City of Tualatin

ARCHITECTURAL REVIEW FINDINGS AND DECISION

**** APPROVAL WITH CONDITIONS ****

Case #:	AR-15-06
Project:	Meridian Business Park – Hale North – Buildings G & H
Location:	17400 SW 65th Ave (Tax Lots 21E 18BC 00600 & 700)
Applicant:	Sander Kohler, CIDA, Inc. (503-226-1285); Mike Berrey, Berrey Properties LLC (CIDA Project No. 140236.01)

Existing Conditions Excerpt

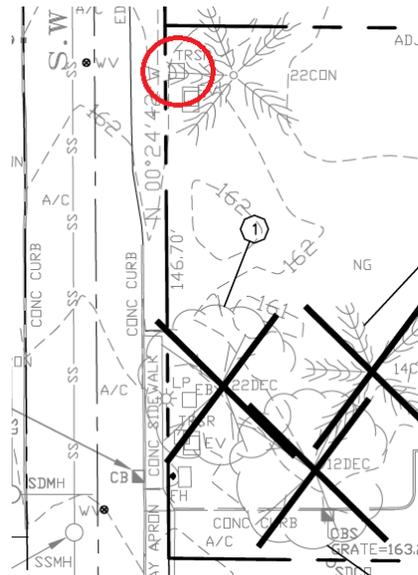
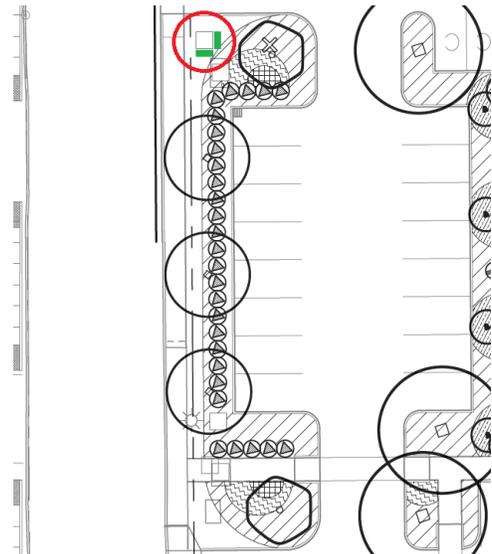
The site and landscape plans show no new at-grade or rooftop electrical and mechanical equipment. The existing conditions and landscape plans show a transformer along SW 65th Avenue at the northwest corner of Lot 700 along what would be the south side of the northern of two driveways at SW 65th Avenue.

As the excerpted illustrations below show, the transformer lacks any screening and can be screened with shrubbery on the east and south sides, with the west side remaining open to maintain opening to its access doors and the north side remaining open to help maintain vision clearance area at the driveway.

Because the transformer lacks screening, staff is applying a condition. The applicant needs to revise the site plans as necessary to note or show all existing and new at grade and rooftop electrical and mechanical equipment and its screening. (At grade, it applies to boxes resting at grade, not vault covers flush with grade.)

- The applicant shall revise the site plans as necessary to note or show all existing and new at grade and rooftop electrical and mechanical equipment and its screening. (At grade, it applies to boxes resting at grade, not vault covers flush with grade.)

PLANTING PLAN
L1.0
 140236.01
 © 2015 CIDA, P.C./CIDA ALL RIGHTS RESERVED

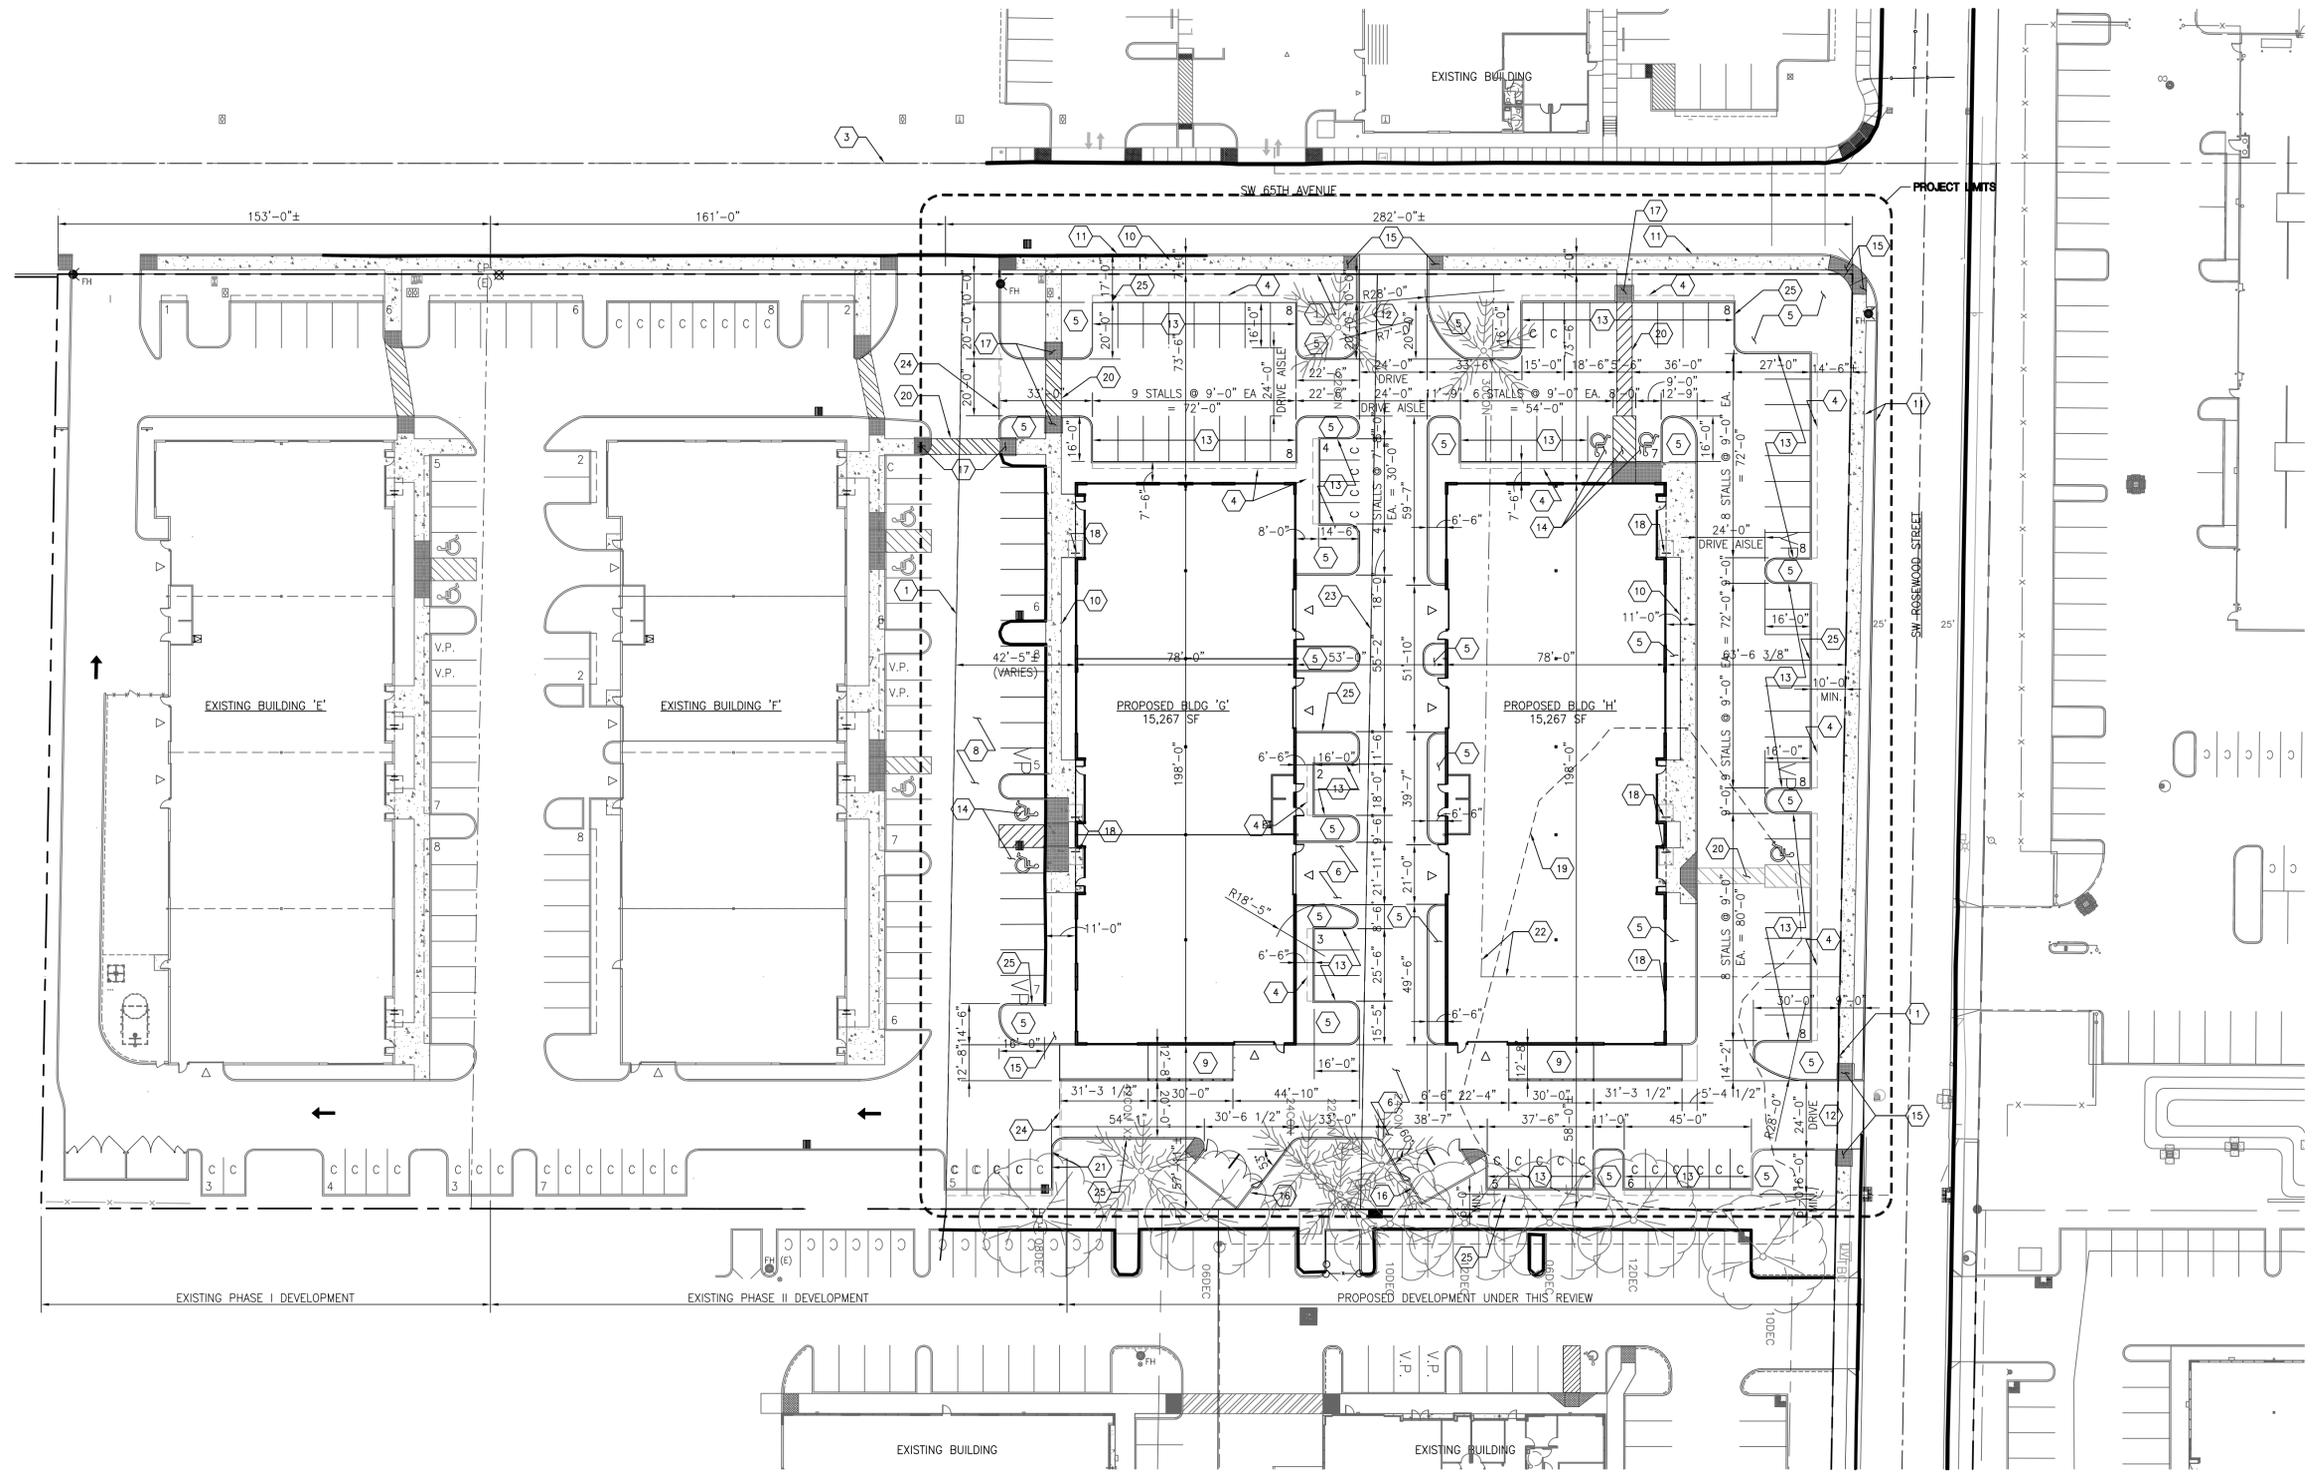
Thought the site plans cover sheet under the header Zoning Code Information tabulates total landscape square footage for each lot, because it does not specify information for the requirement of (1), landscape island area, staff cannot determine compliance and so is applying a condition. Because neither it nor the landscape plan specifies information for the requirement of (3), parking area tree count, staff cannot determine compliance and so is applying a condition.

- The applicant shall revise the landscape plan to for each lot tabulate, call out, or otherwise symbolize those deciduous shade trees dedicated to and uniformly distributed throughout the parking area.

1 BLDG G SOUTH ELEVATION
A2.1 1/16" = 1'-0"

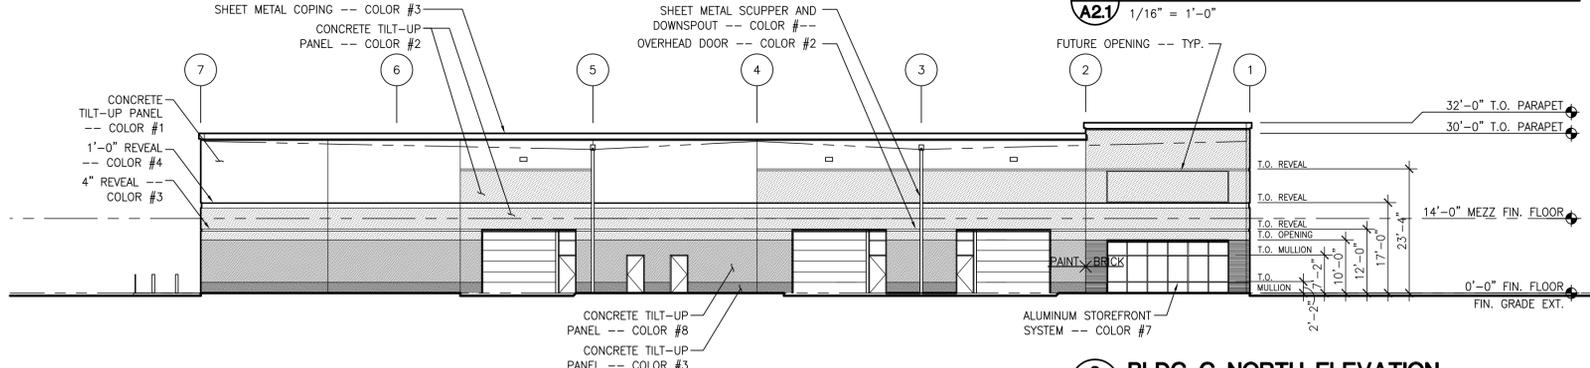
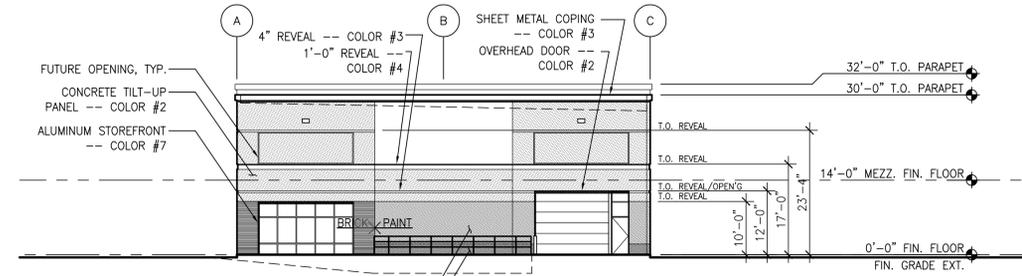
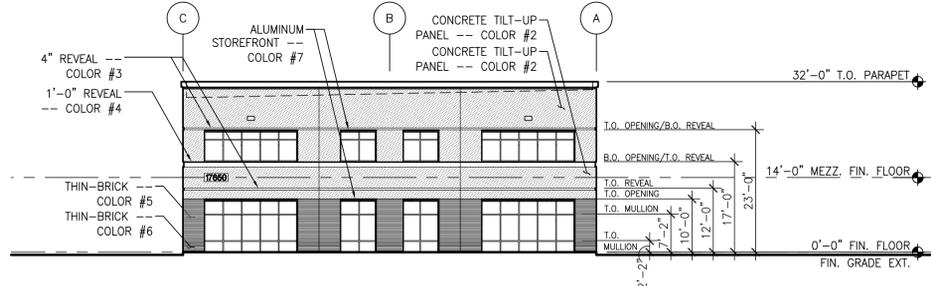
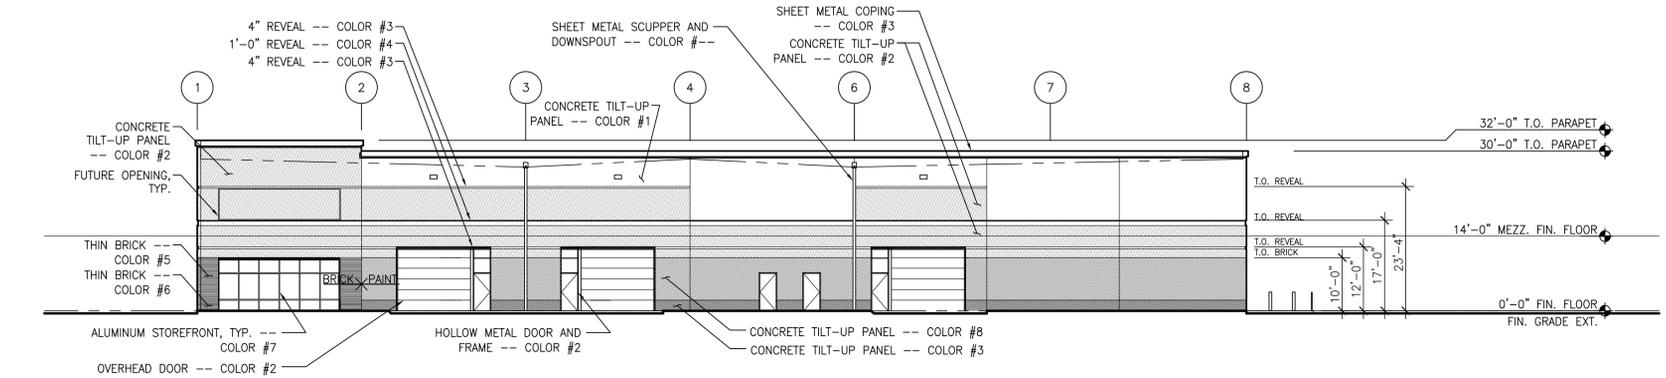
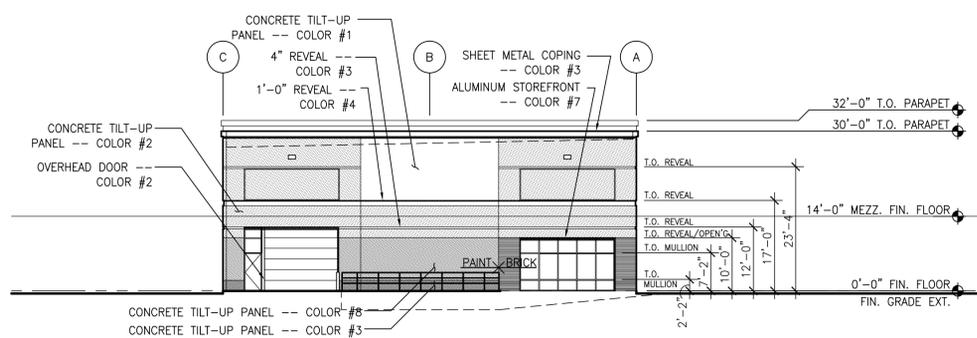
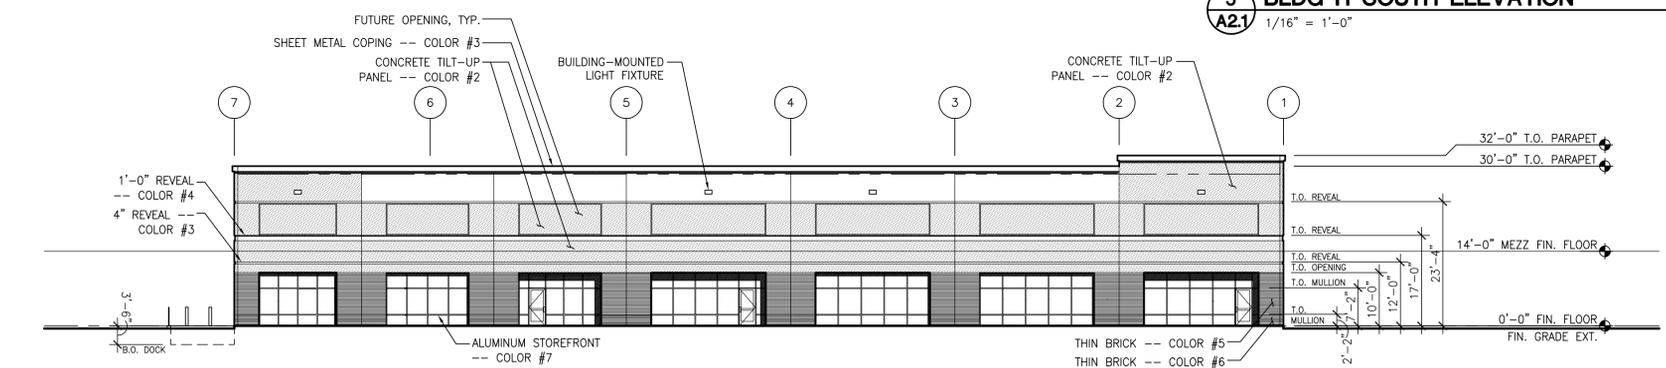
Regarding (d), because the elevations neither note nor illustrate address numerals, staff is applying a condition to meet the requirement of (d). The applicant needs to revise the elevations to illustrate address numerals that meet the needs of Tualatin Valley Fire & Rescue (TVF&R). Refer to Item 1 within the attached TVF&R agency comment.

- The applicant shall revise the elevations to illustrate or note address numerals that meet the needs of Tualatin Valley Fire & Rescue (TVF&R).
